HISTORIC AND DESIGN REVIEW COMMISSION

HDRC CASE NO: 2022-505
ADDRESS: 515 CLUB DR
LEGAL DESCRIPTION: NCB 7070 (R MATAMOROS SUB), BLOCK 9 LOT 25
ZONING: RM-4. H
CITY COUNCIL DIST.: 7
DISTRICT: Monticello Park Historic District
APPLICANT: Gilbert Garza/Garza Design-Build LLC
OWNER: Celeste Leija
TYPE OF WORK: New construction of a 1-story, single-family residence
APPLICATION RECEIVED: November 04, 2022
60-DAY REVIEW: Not applicable due to City Council Emergency Orders
CASE MANAGER: Rachel Rettaliata

The applicant is requesting a Certificate of Appropriateness for approval to construct an approximately 2,400-square-foot 1-story, single-family residential structure.

GARZA Design*Build, LLC Is Pleased to Submit this **Responses to Comments** Historic Preservation Regarding **Mr. and Mrs. Leija Proposed New Residence** located at 515-Club Dr / Monticello Park.

04. PROPOSED STONE COLUMNS ELEVATION DET.
SCALE: 3/4" = 1'-0"

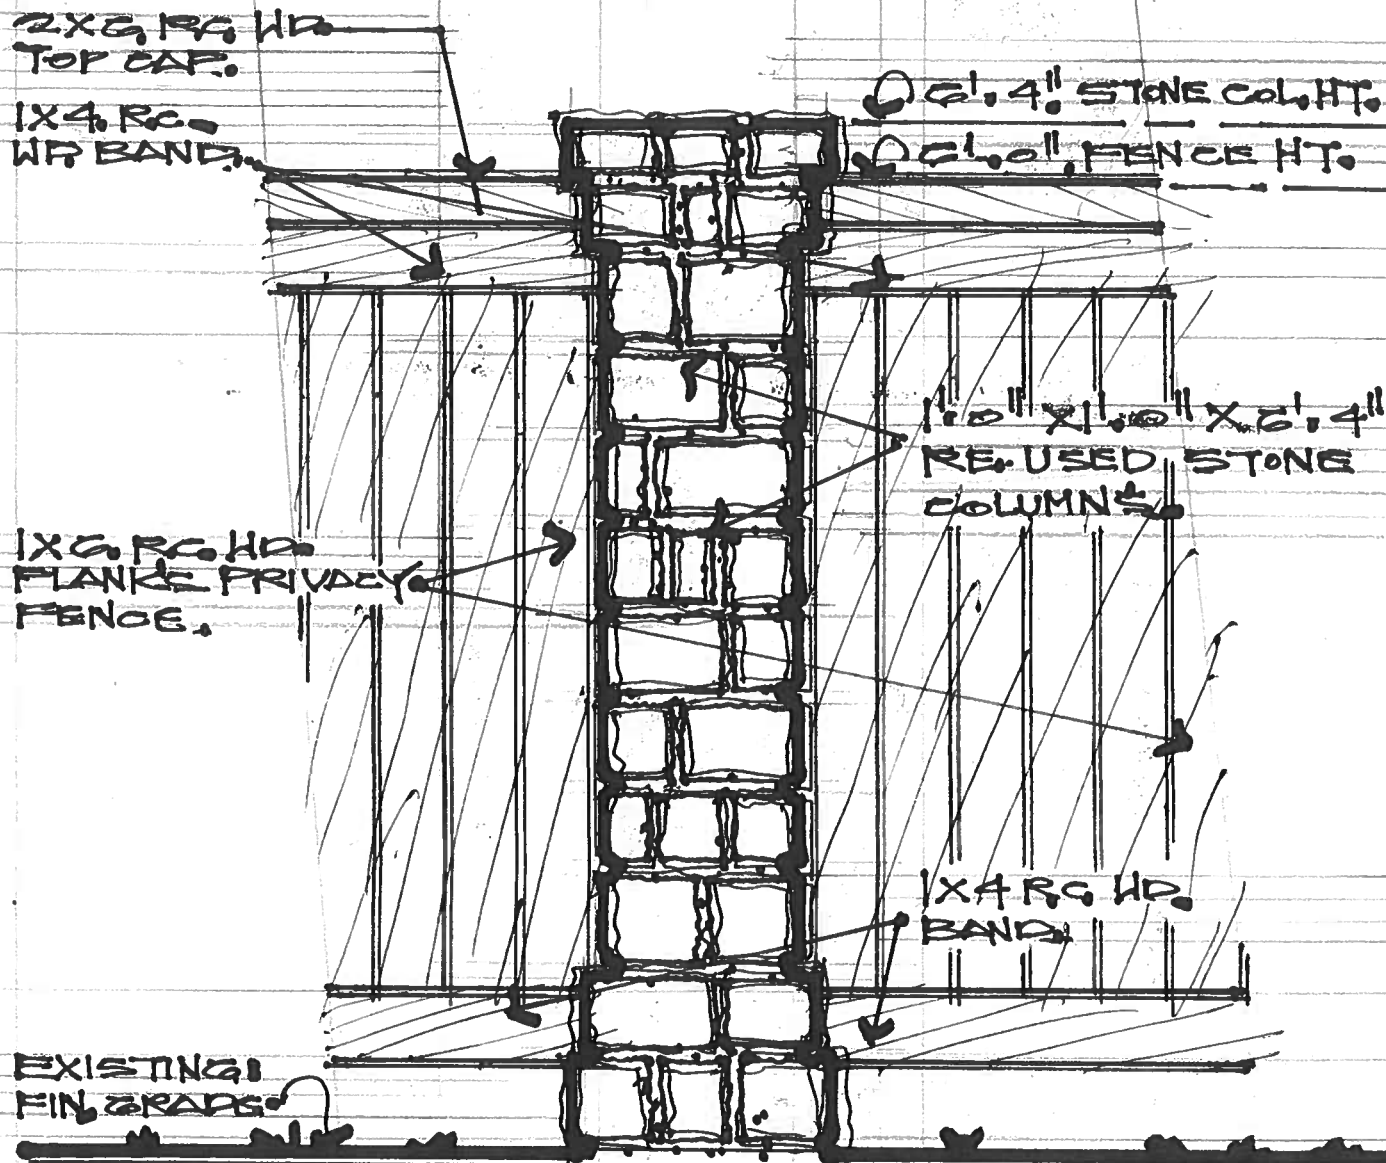
- XI : Submit a Final Proposed Landscaping Plan with Planting details and a Proposal to Re-Use existing Stone mats
 - * R. : **Previously submitted. (Article previously submitted.)**

NOTE: 04. STONE COLUMNS MATERIALS TO BE
REFURNISHED FROM EXISTING STONE WALL.
